DEVELOPMENT REVIEW BOARD  
SUPPLEMENTAL SUBMITTAL

PROJECT NO. 2018-001579

SUBMITTAL DESCRIPTION: Departmental comments indicated a number of items to be addressed in a deferred hearing date, indicated above for multi-family apartments project at 7500 Indian School Rd in the Winrock Town Center. Responses to the comments and revised sheets are provided.

This letter outlines the modifications that have been made to the Apartments at Pennsylvania St and Indian School Rd application for a major site plan amendment to the approved Winrock Town Center Site Development Plan (PR-2018-001579) to address the agency comments that were received.

SITE PLAN

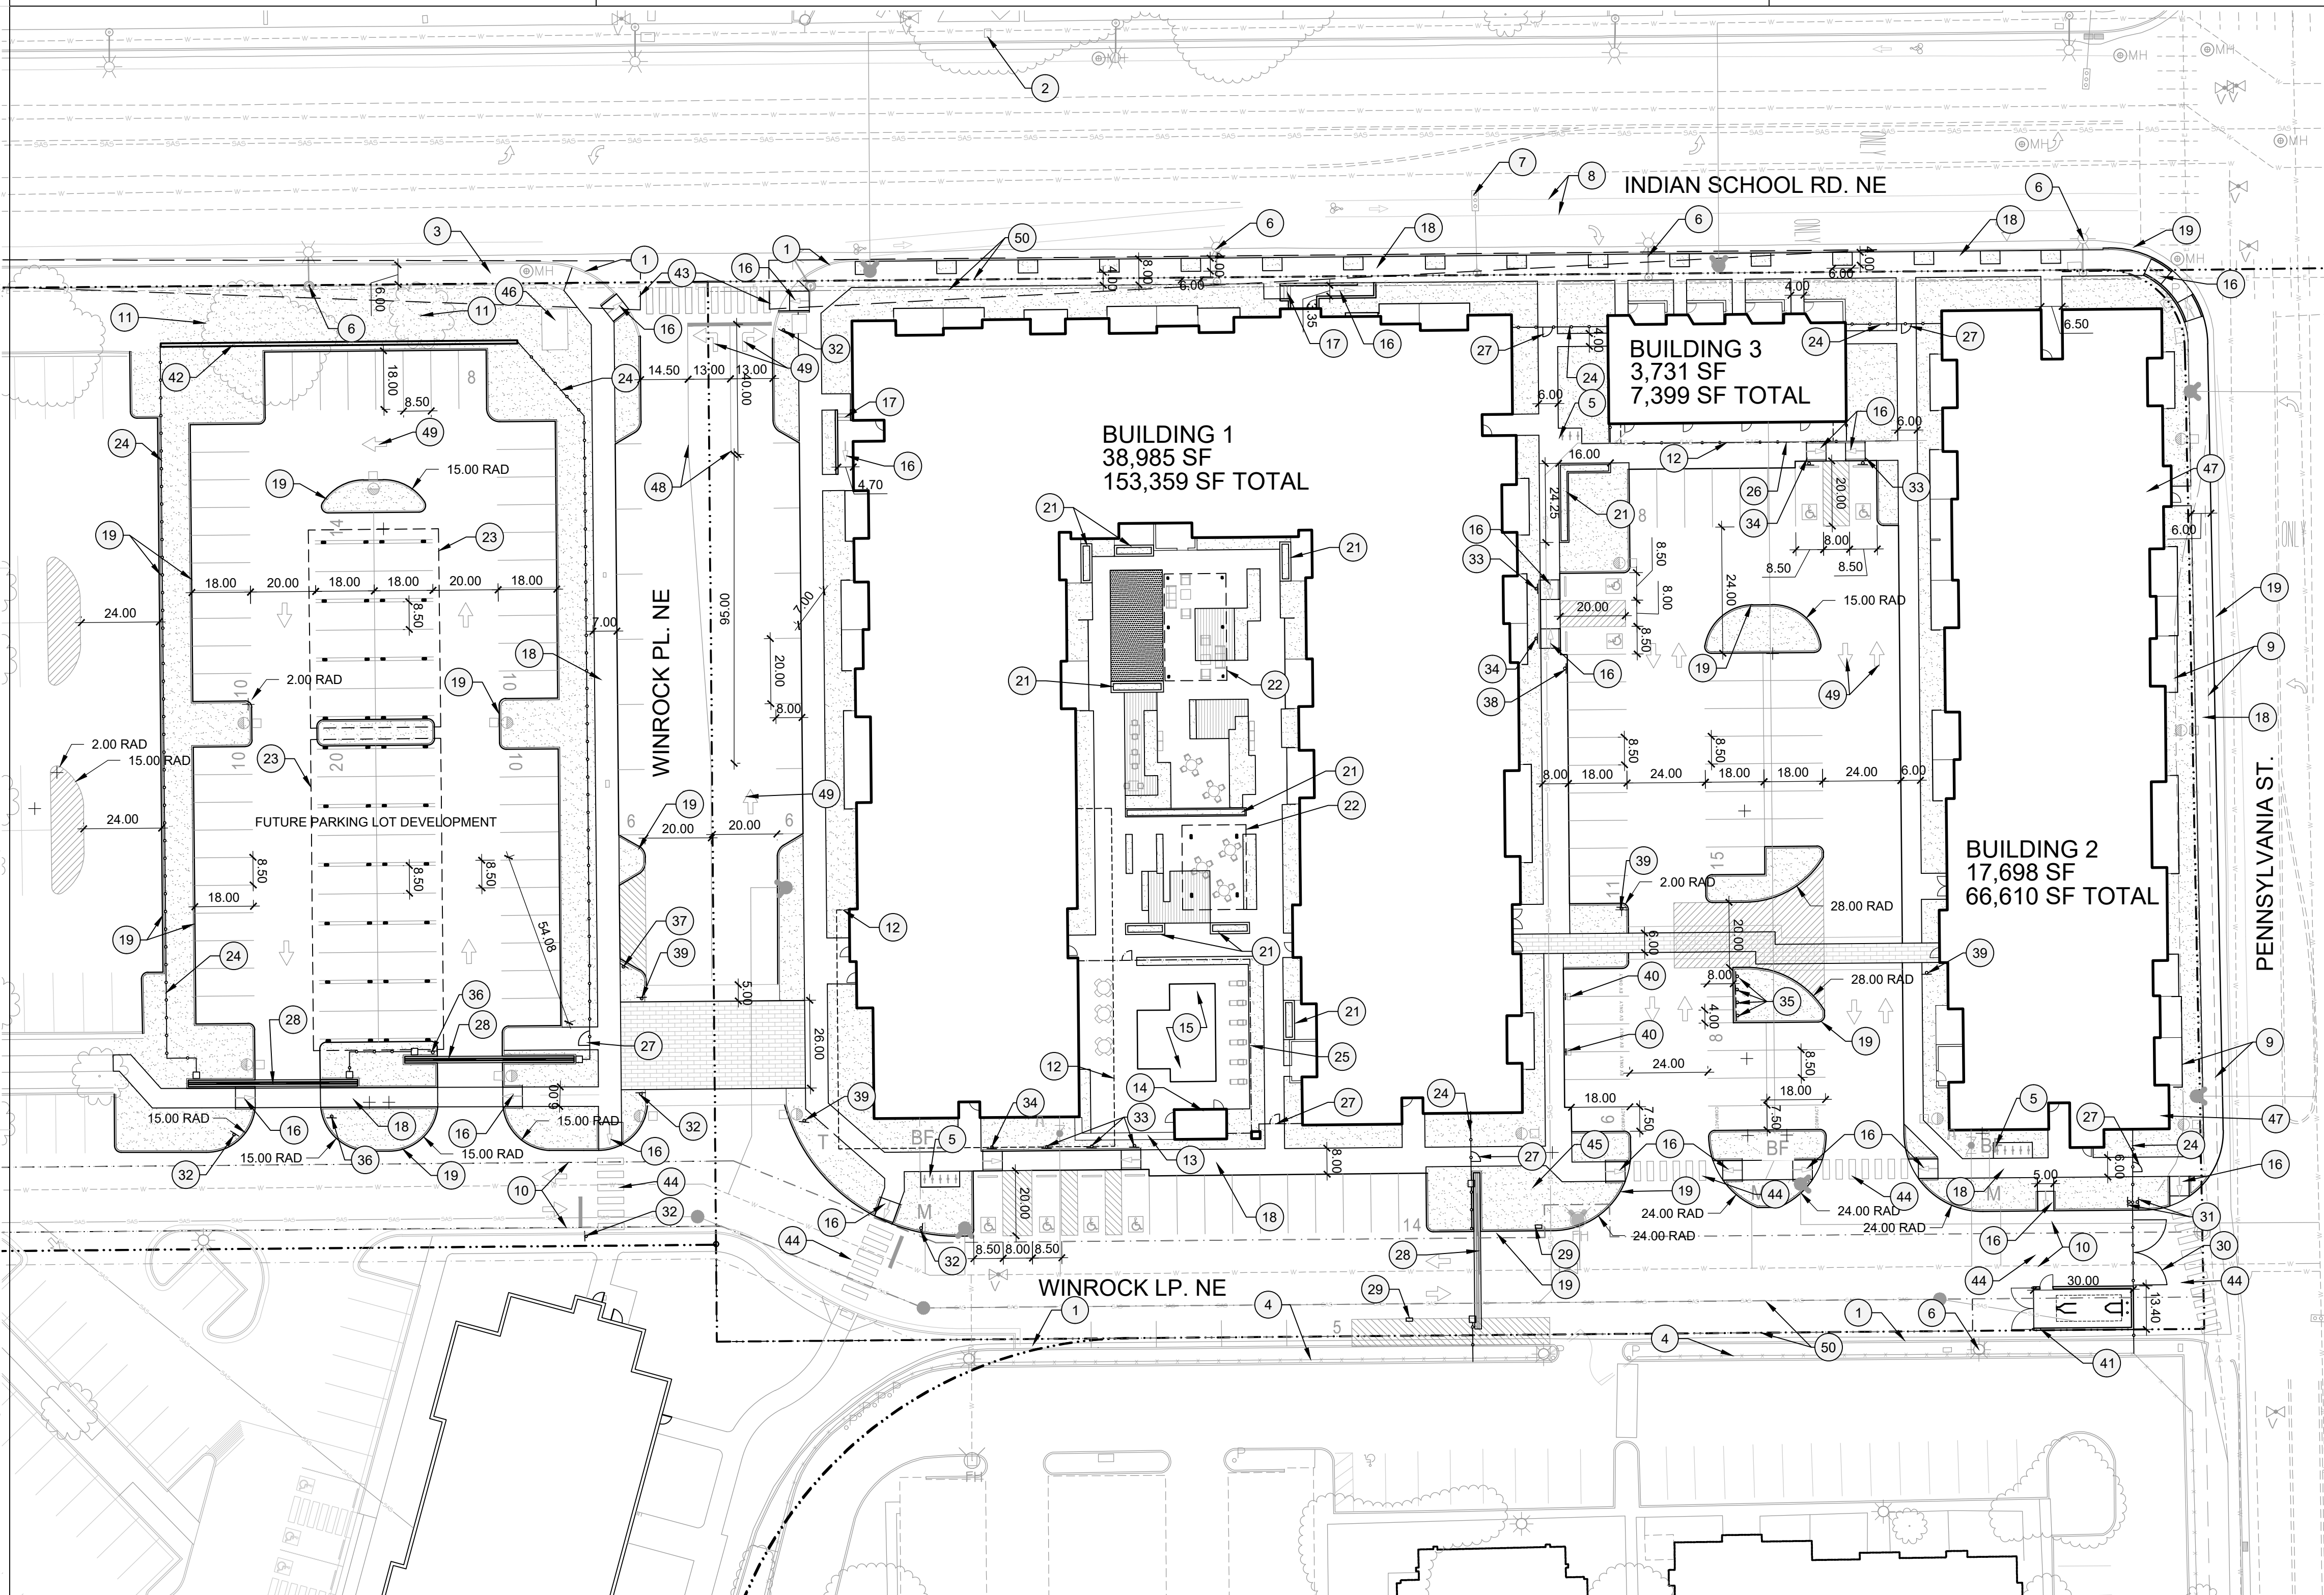
4. Clarify on the plan that public improvements shall be built per the work order drawings.

5. For a road exiting onto Indian School Road, provide length of lane transitioning and specify color of striping and pavement markings.

7. Update right-of-way lines and any new easements from the plat on the site plan.

- a. Availability statement #201105 has been issued and provides the conditions for service.
- b. Site Plan
  - i. Please provide documentation that the ABCWUA will have ability to access the gates (key note 28 and 30) for maintenance.

*Site plan has been updated to include a note "Public improvements shall be built per separate work order drawings."*

*Site plan has been updated to include a dimension. Striping and pavement markings to be white unless at designated accessible parking spaces. Paint color is noted on the site detail sheet.*

*Site plan has been updated to include new public sidewalk easement and new ABCWUA sanitary sewer easement.*

*Access will be provided to the Fire Department, ABCWUA, and Solid Waste via fob access/keyed entry. Gate at Pennsylvania (keyed note 30) is an emergency exit only gate.*
